Appl. No. 10/049,950
Amdt. Dated November 24, 2003
Reply to Office Action of May 22, 2003

REMARKS

ANNOTATED SHEET SHOWING CHANGES

FIG 4B

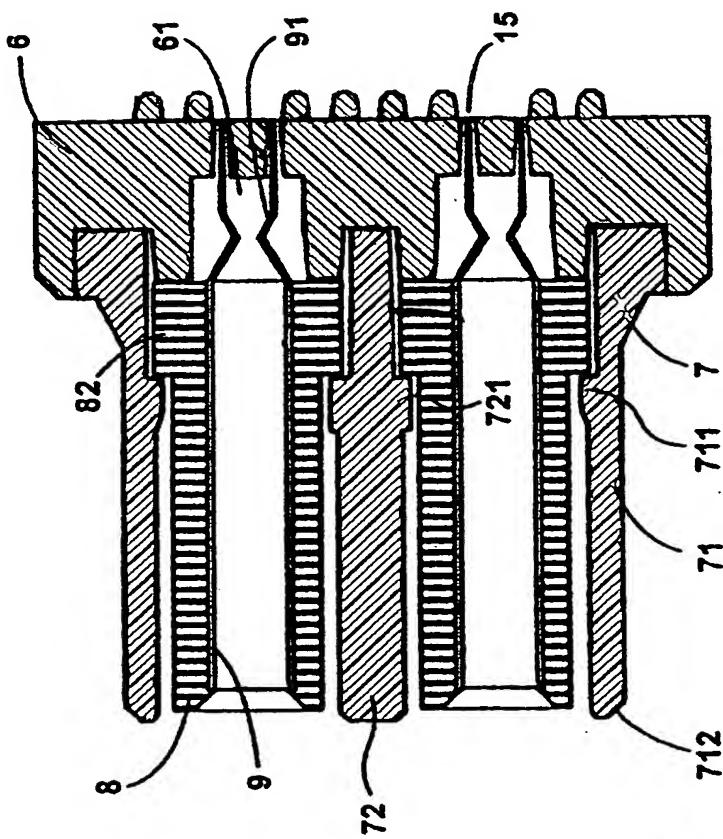
The Examiner objected to the drawings under 37 C.F.R. 1.84(h)(3) or MPEP § 608.02 because the cross-hatching of the insulative parts indicate a metallic material. Applicant's have submitted new drawings so that the cross hatching of the insulative parts, shown in the section views of Figures 4A, 4B and 4C, now properly indicate non-conductive material, as requested by the Examiner.
